Director's Report

Project Name: 9101 Highland
 Description: Preliminary site plan approval recommendation & special land use approval
 Date on Agenda this packet pertains to: December 5, 2024

RE: 9101 Highland Road-Proposed Commercial Development- Preliminary Site Plan Review – 2nd Review

**Preliminary Site Plan / Special Land Use Review
for
White Lake Charter Township, Michigan**

DRAWING: C-1

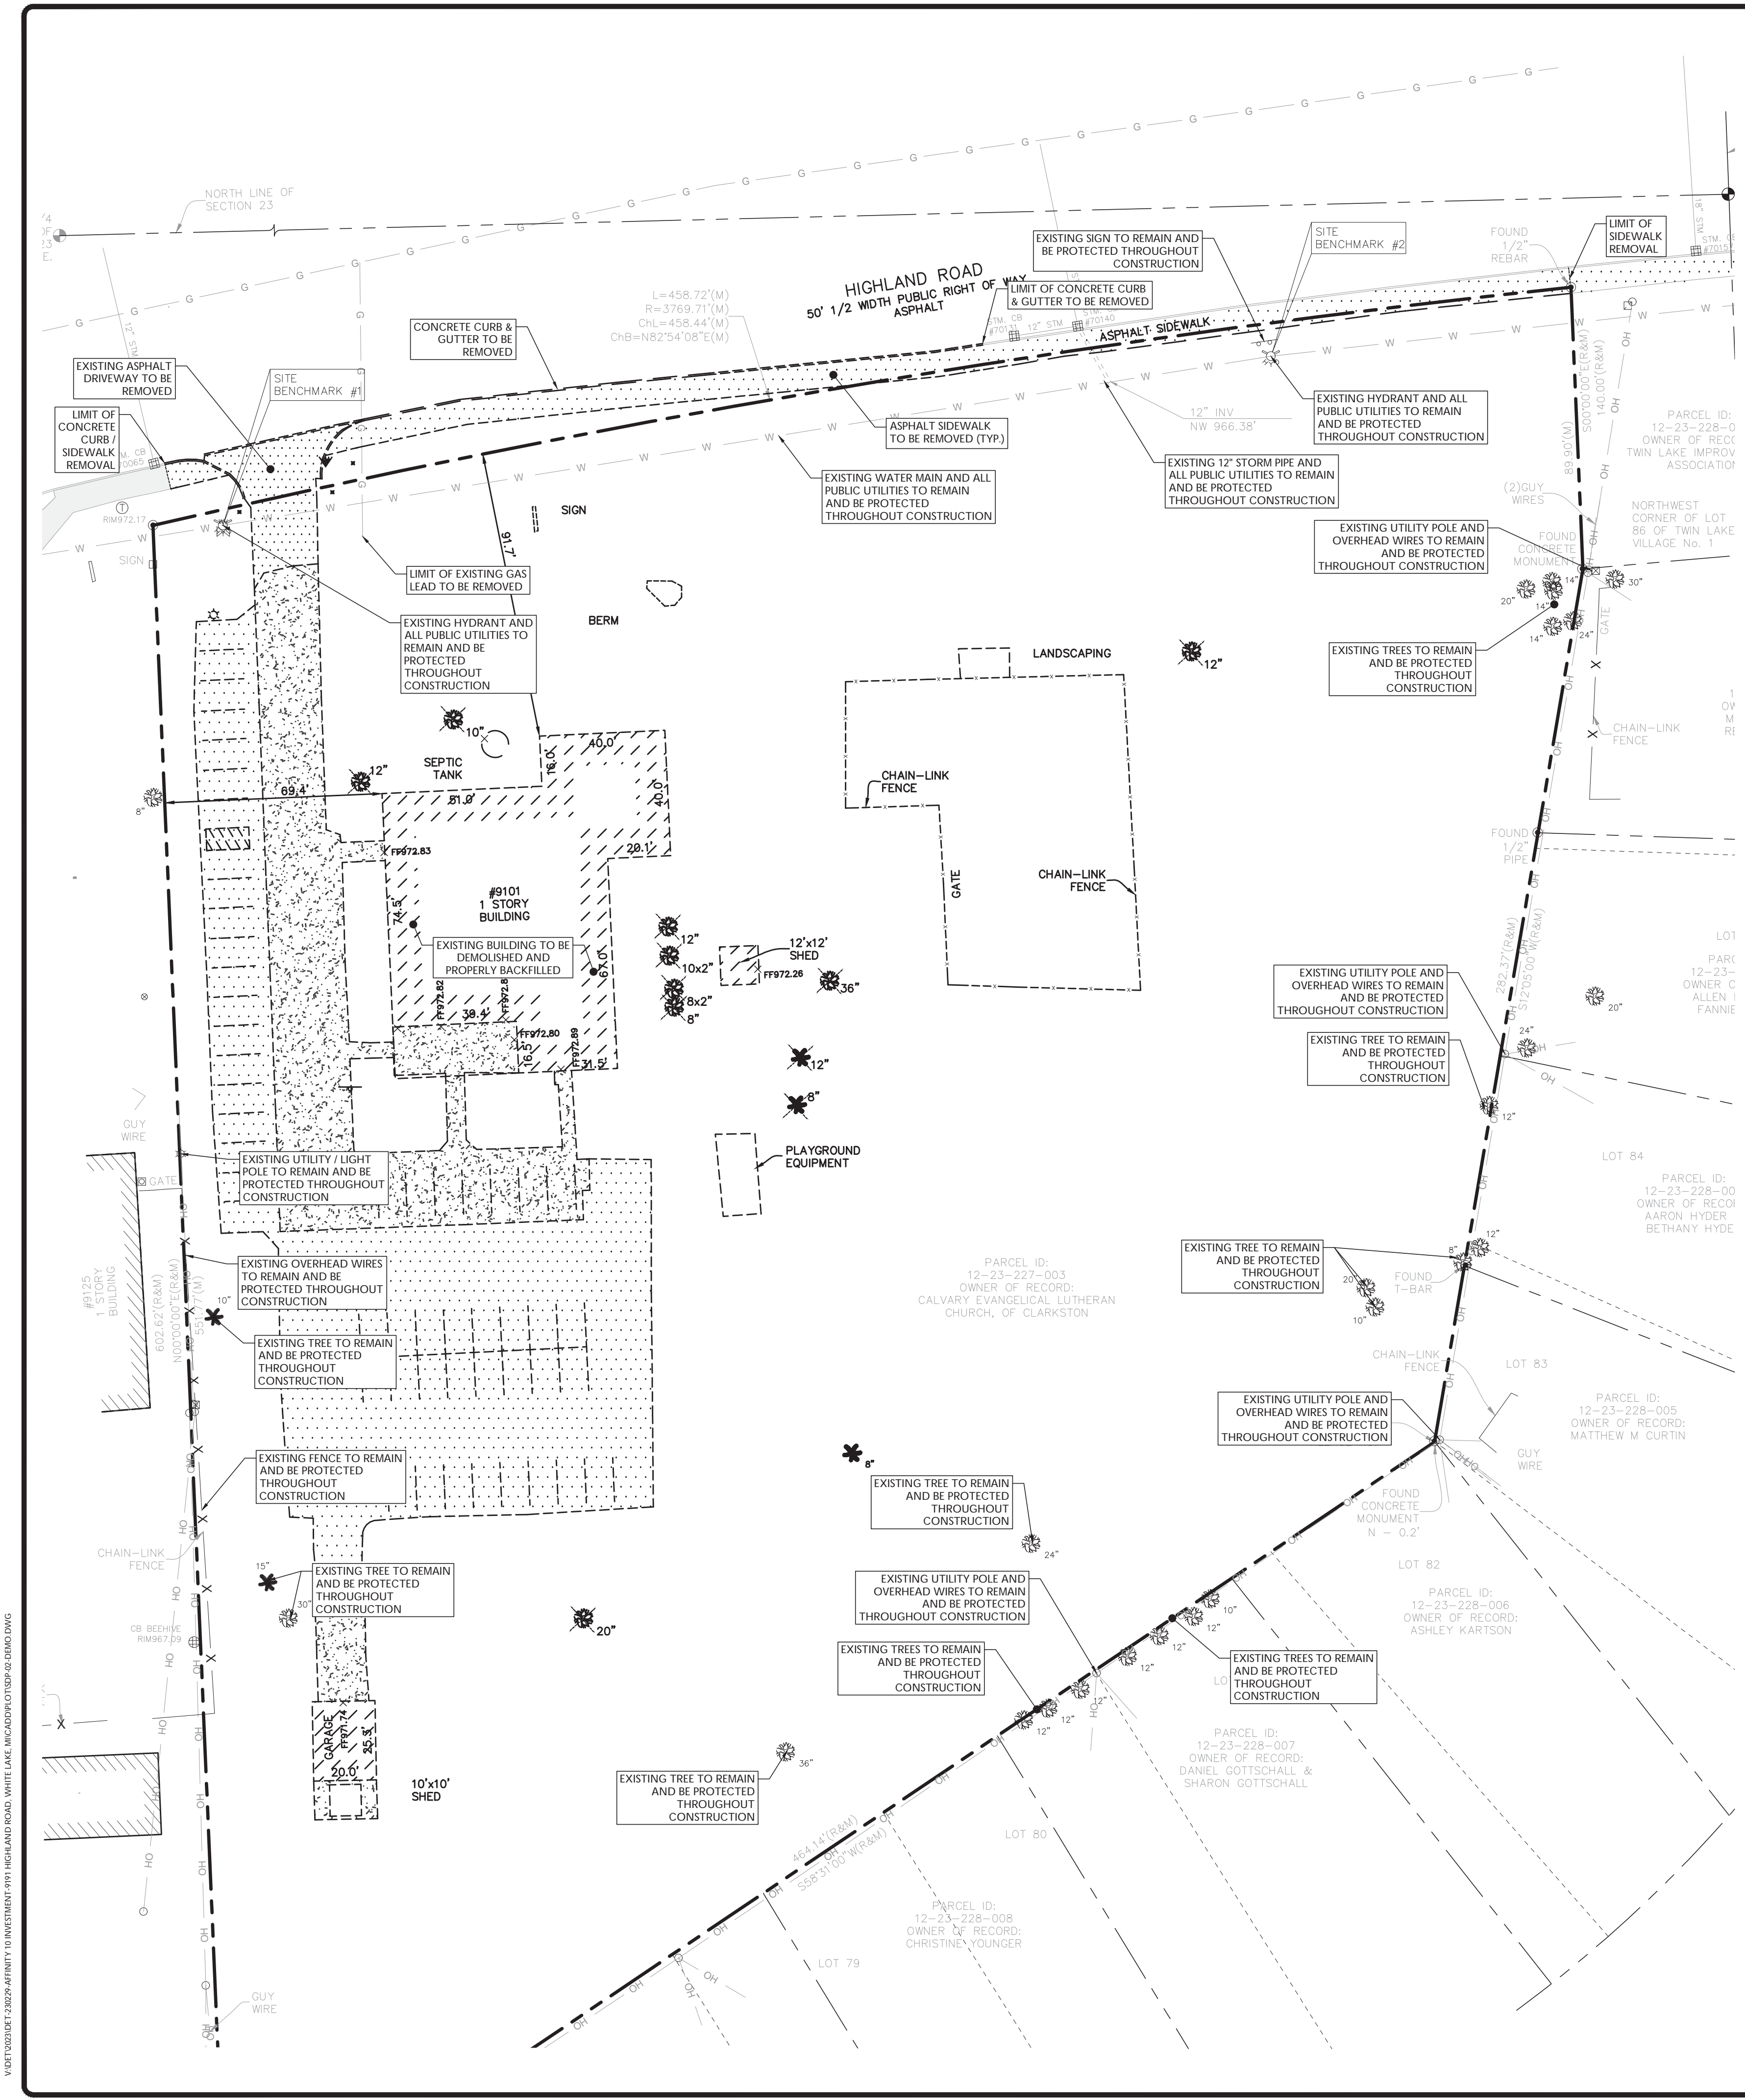
- a) *Cover sheet C-1- Provide ALTA/NSPS Land Title Survey with next submittal. Comment addressed at the preliminary level and remains. The survey has now been provided. Please provide surveyor seal and signature on this sheet on the Final Site Plan/Final Engineering Plan.*

DRAWING: **C-4**

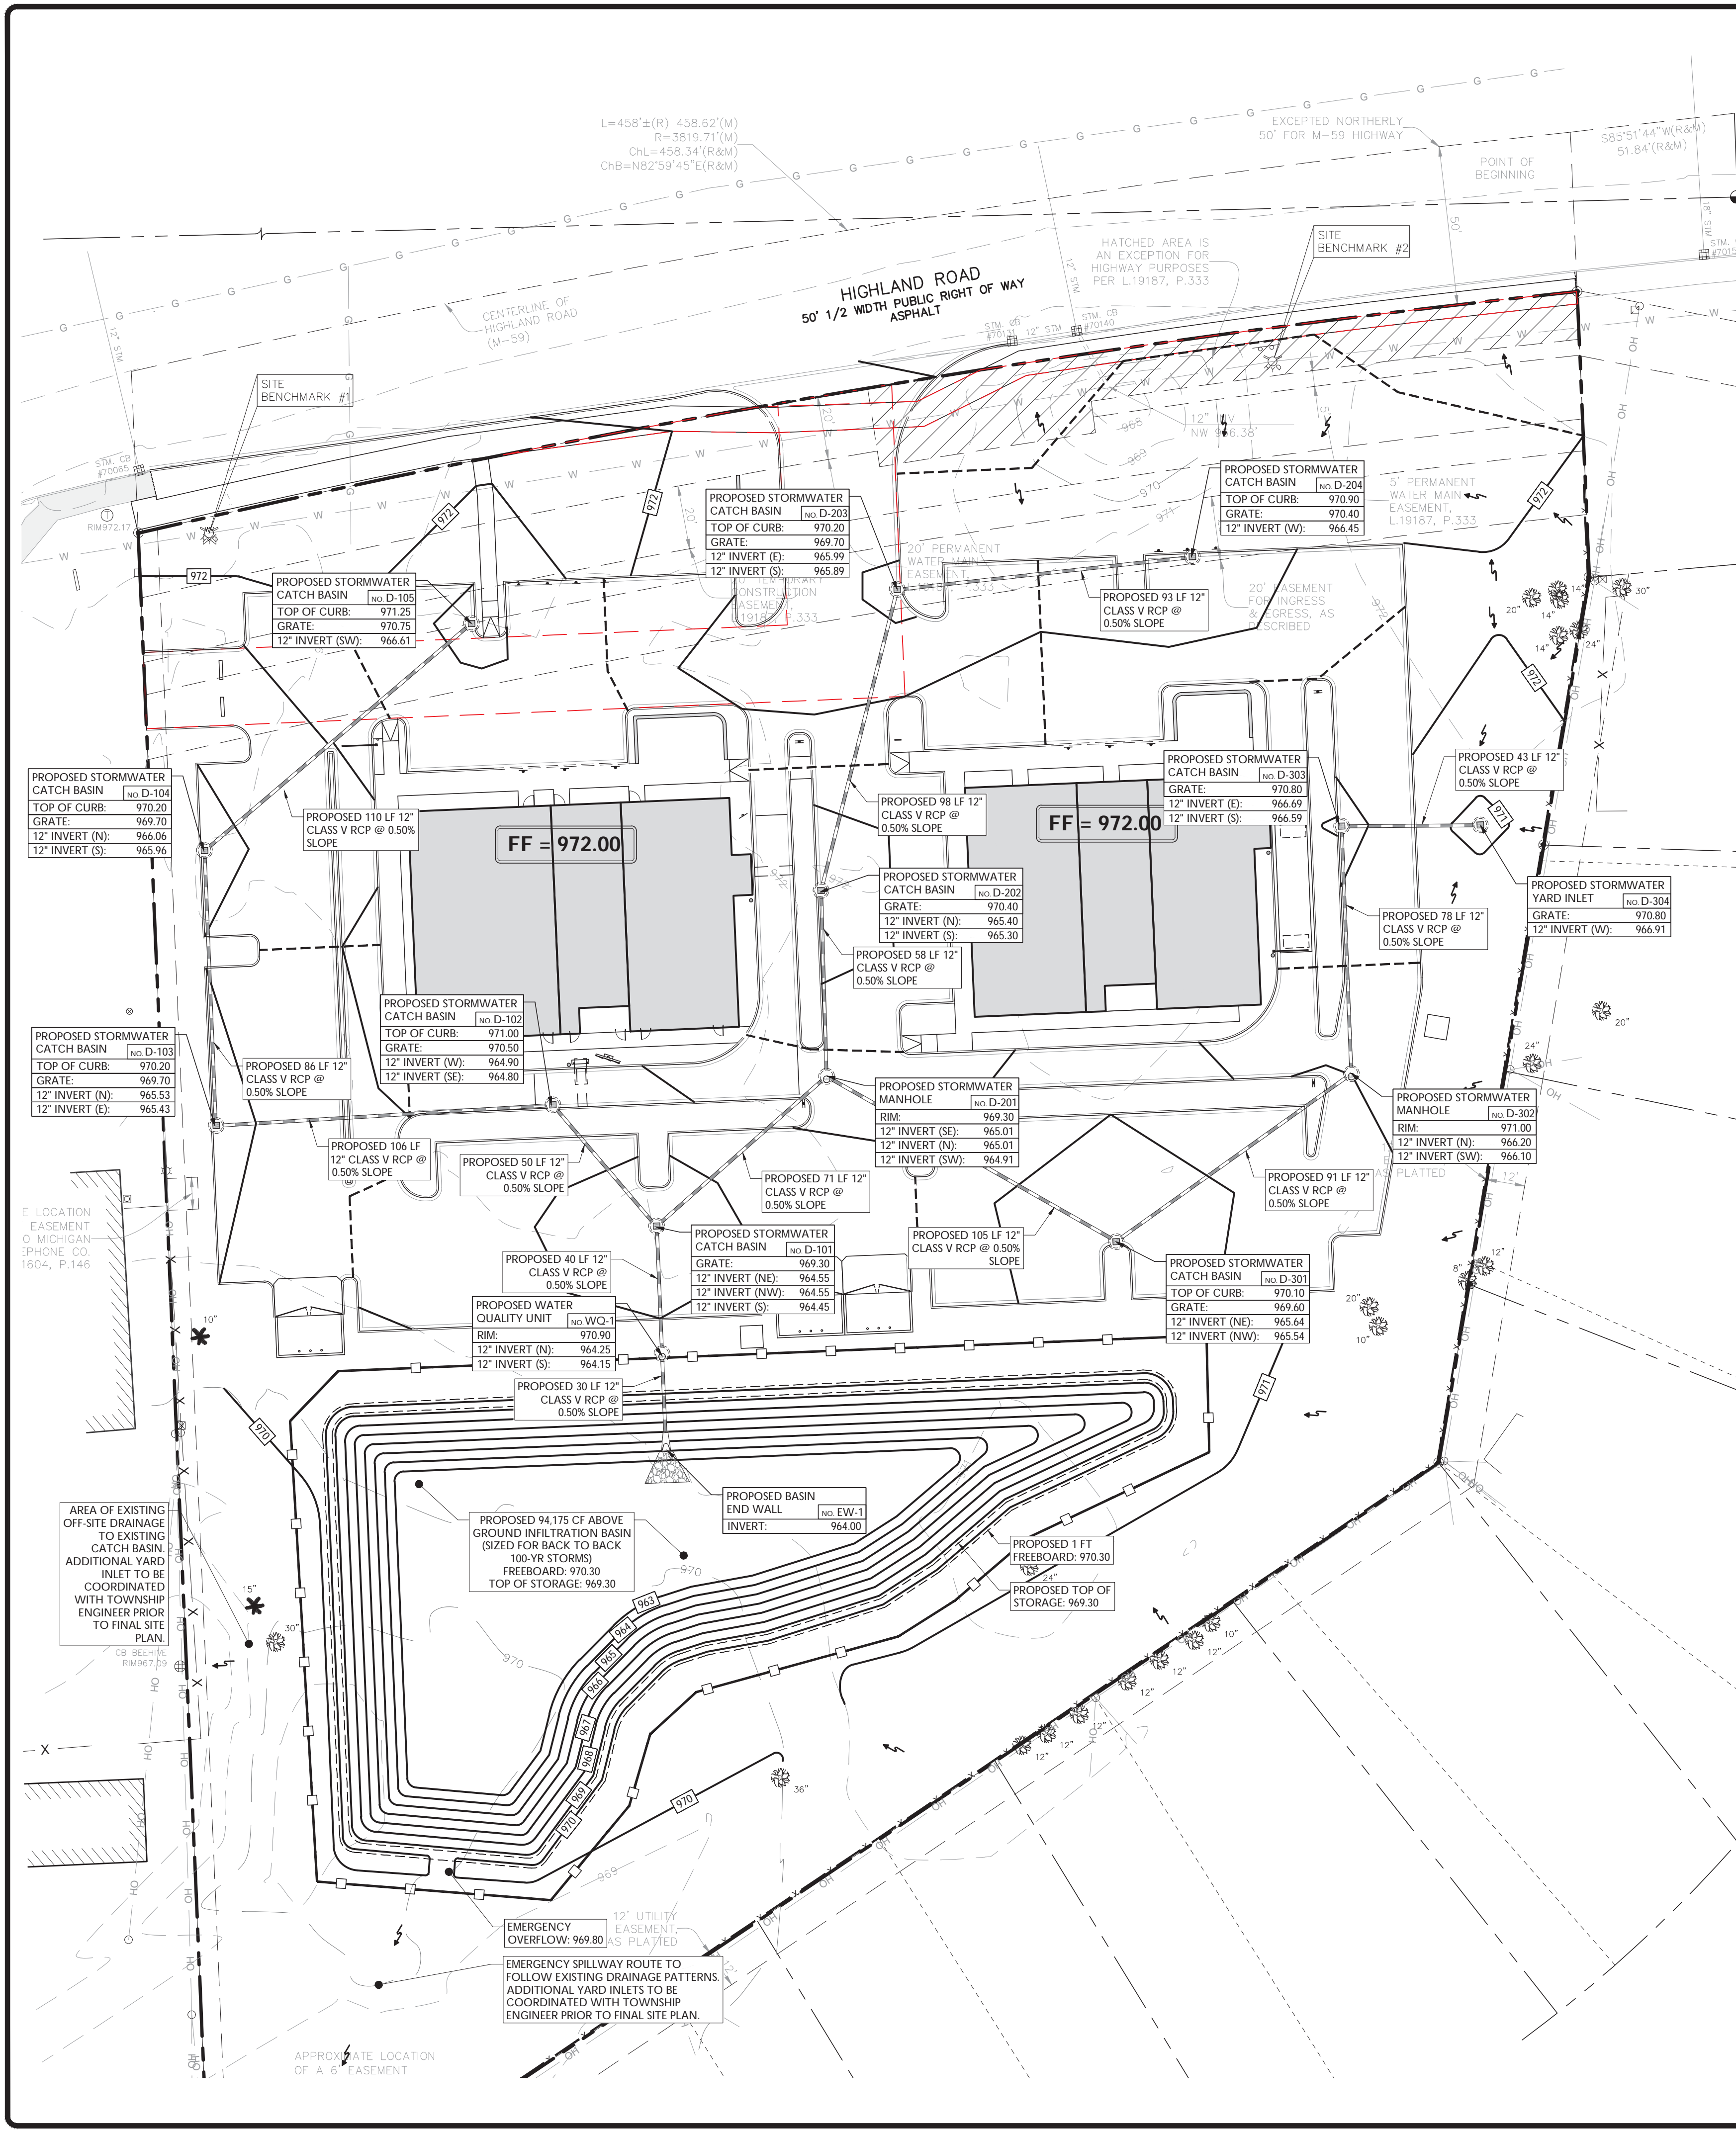
- k) *Sheet C-4- What is the grading intent for the northeastern greenspace area of the site? We note that there is an existing storm sewer end section which connects to the existing 12" diameter storm sewer that crosses M-59. It is assumed that this end section is to collect the drainage at the low point of approximately 966' and route the drainage to the north under M-59; however, the existing CB to the*
-

north (#70140) shows a higher invert elevation than the existing ES elevation to the south. Please clarify. We also note that the site post- development runoff to this end section shall be $< \text{ or } =$ to the current runoff (Q) to this area. **Comment addressed at preliminary level and remains. The existing pipe shall be removed, and the area regraded such that the depression shall be filled. Per the design engineer, calculations are intended to be provided on the FSP/FEP to demonstrate post development runoff to the M-59 right of way be $< \text{ or } =$ to the current runoff.**

- l) *Sheet C-4- Grading Notes- Note 5-Minimum slope for concrete surfaces can be 0.50% as per WLT Engineering Standards.* **Comment addressed. Note has been updated.**

- m) *Preliminary grading of the site has been proposed and demonstrates general drainage patterns mainly within the confines of the proposed impervious areas; please provide on the revised preliminary site plan general proposed grading for all greenspace areas. A more detailed grading review will be provided at the time of Final Engineering Plan submittal/review.* **Comment remains.**

Topography: Sheet C-4 show existing site topography as well as the proposed grading. With the exception of a natural depression along Highland Road (M-59) on the east side of the site, the lot is predominantly flat. Minor grading will be required to support proposed structures and site improvements with more extensive excavation required for the proposed detention pond south of the development.
